UNITED STATES PATENT AND TRADEMARK OFFICE

APPLICATION NO.	FILING DATE	FIRST NAMED INVENTOR	ATTORNEY DOCKET NO.	CONFIRMATION NO.
09/980,462	07/19/2002	Michael Johannes Vellekoop	30893-1059	6416

Office Action Summary

DETAILED ACTION

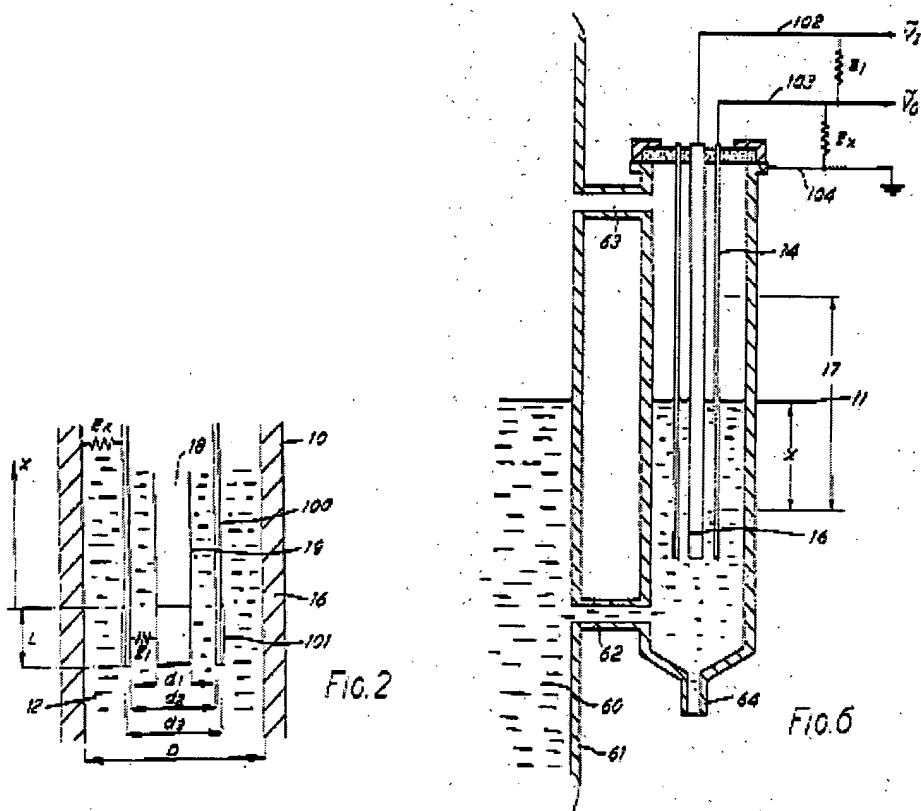
8. Claim 5 is rejected under 35 U.S.C. 103(a) as being unpatentable over Platkowski in view of Viegut et al WO 96/24030.

Platkowski does not teach the bottom of the reservoir is formed by silicon wafer. However, Viegut et al teaches a liner 58 may be disposed within the aperture 31 at a side thereof opposite to the side thereof adjacent the conductors 44 and 46. The liner may be a coating or other treatment applied to the aperture. The liner comprises a low friction substance, such as a silicone and the like. One skill in the art would incorporate this technology with Platkowski's invention to reduce a meniscus curvature formed by a fluid disposed within the liner and thereby within the receptacle 30.

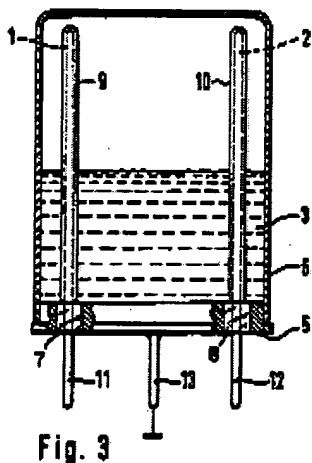
Wallrafen 5092171 further shows in FIG. 3, the two electrodes 1 and 2 are held by the bottom 5 of a metal housing 6 obtainable for oscillating quartzes. Glass lead-

through 7, 8 are provided for insulation. The housing is sealed hermetically by corresponding soldering. The liquid 3 covers about one-half of the electrodes 1, 2. Extensions of the electrodes 1, 2 serve at the same time as soldering pins 11, 12. A third soldering pin 13 connected directly to the housing bottom 5 forms the common counter-electrode (col. 4). In figure 3 shows the design choice an inventor made use to attach probes/electrodes to a container.
